City of Albuquerque

RE: DRAINAGE PLAN SUBMITTAL OF LANDS OF LINCOLN ROAD LIMITED, TRACT 5 AND 6, RECEIVED OCTOBER 9, 1986 FOR BULK LAND PLATTING APPROVAL (A-11/D2)

CONFERENCE RECAP

ONSITE AND OFFSITE DRAINAGE BASIN PLAN FOR TRACT 5 AND 6

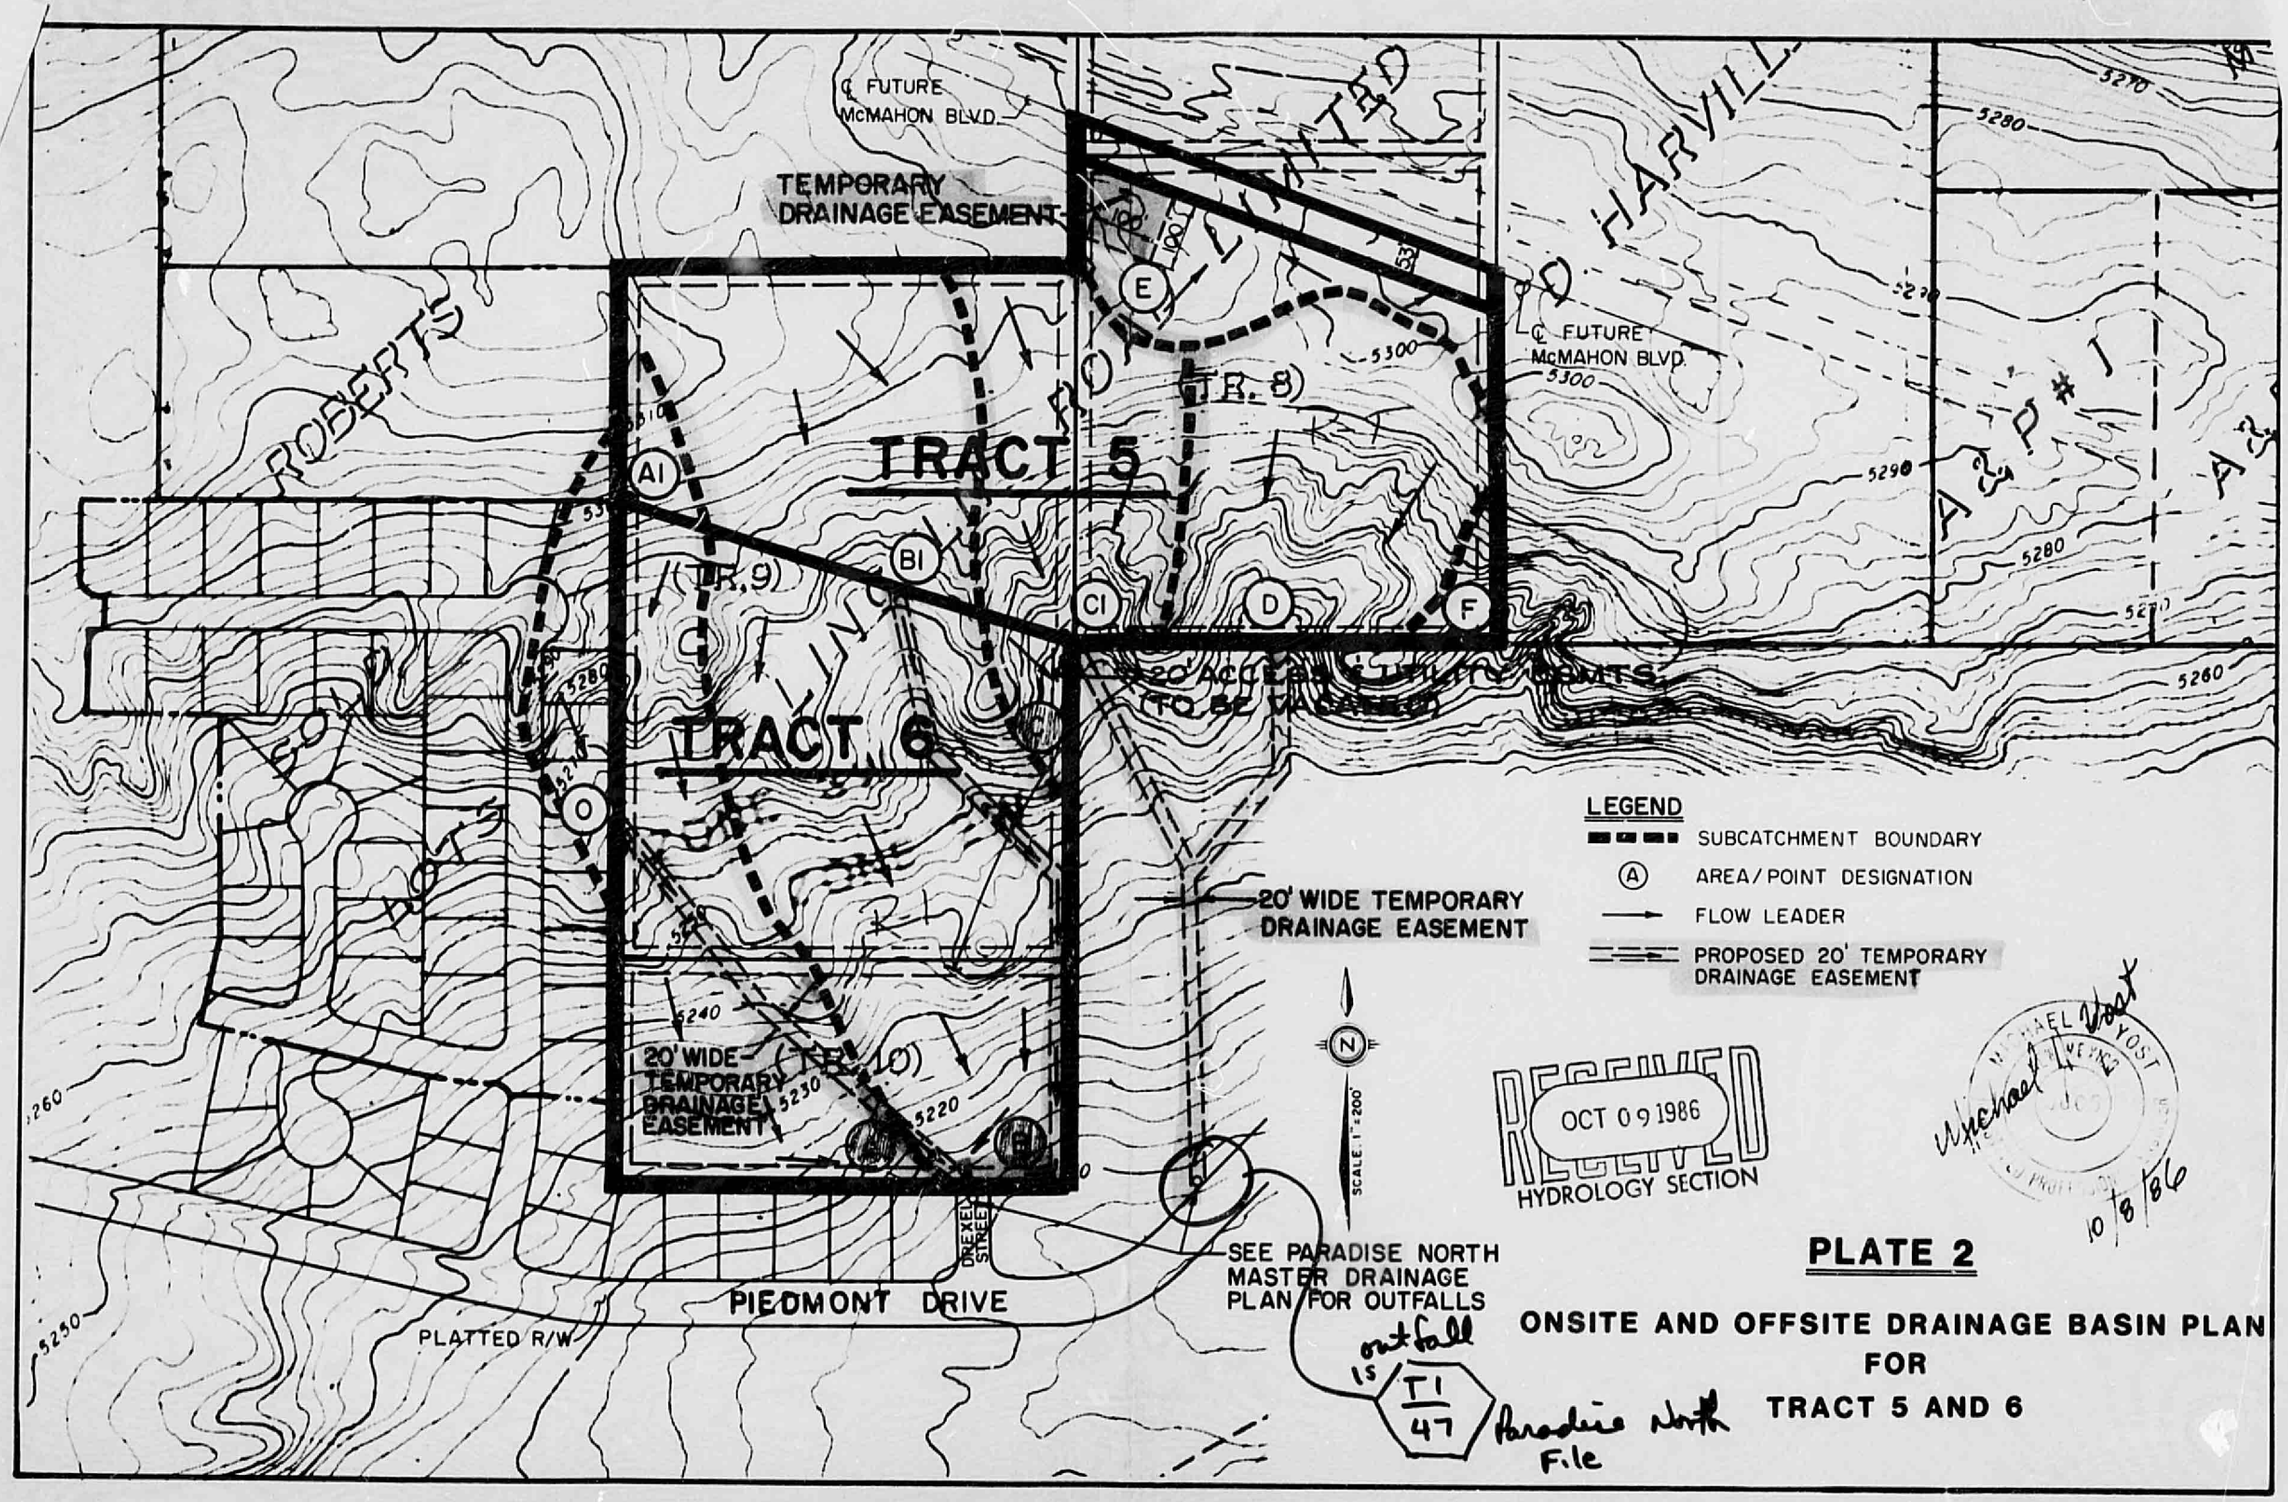
The off-site drainage easements identified for an outfall system for Tract 5 are entirely the responsibility of the affected property owners, before any further platting or development of Tract 5 can proceed.
